Access Compliance Report

Public Rights-of-Way

(Curb Ramps)

Intersection ID: 50905	Main Street: HELENA_PARK_LN	Cross Street: KARRAS_COMMONS_WY	Location: NE
ADA ID: 9C7C2CC3C596	Ramp Type: Perp	Initial Pass/Fail: Fail	Overall Compliance: No Severity Score: 22.5

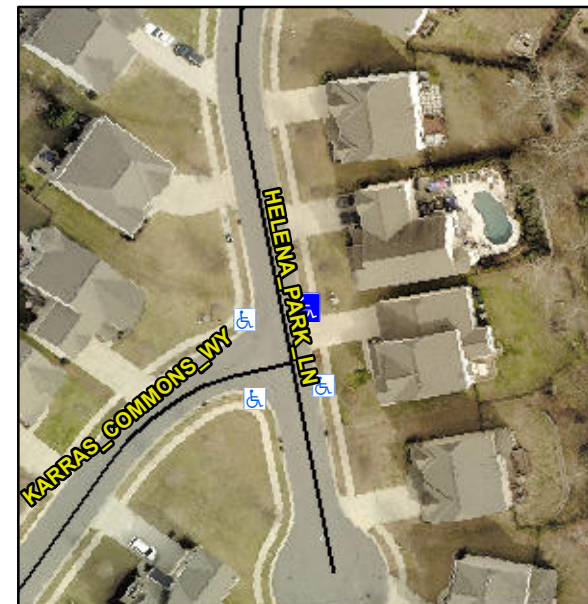
R304.5.1, R304.2.2, R304.5.3

Compliance	Description	Data	Compliance	Description	Data
N/A	Ramp Length (in)	48.0	No	Ramp Slope (%)	10.4
No	Ramp Width (in)	47.0	No	Ramp XSlope (%)	3.9
N/A	Flare Type LT	N/A	N/A	Flare Type RT	N/A
N/A	Flare Slope LT (%)	N/A	N/A	Flare Slope RT (%)	N/A
N/A	Flare Traversable LT?	N/A	N/A	Flare Traversable RT?	N/A
N/A	Landing Length (in)	N/A	N/A	DWS Provided?	N/A
N/A	Landing Width (in)	N/A	N/A	DWS Contrast?	N/A
N/A	Landing Slope (%)	N/A	N/A	DWS Length (in)	N/A
N/A	Landing X Slope (%)	N/A	N/A	DWS Full Width?	N/A
N/A	Landing Curb? (Y/N)	N/A	N/A	DWS Offset (in)	N/A
N/A	Shared Landing?	N/A			
N/A	Gutter Ponding?	N/A	N/A	Gutter Slope (%)	N/A
N/A	Gutter Lip Ht (in)	N/A	N/A	Gutter X Slope (%)	N/A
N/A	Painted X Walk1?	No	N/A	Painted X Walk2?	N/A
	X Walk 1 Direction	To W		X Walk 2 Direction	N/A
N/A	X Walk 1 Width (in)	N/A	N/A	X Walk 2 Width (in)	N/A
	X Walk 1 Slope (%)	3.1		X Walk 2 Slope (%)	N/A
	X Walk 1 X Slope (%)	1.1		X Walk 2 X Slope (%)	N/A

Remove & Replace Entire Ramp.
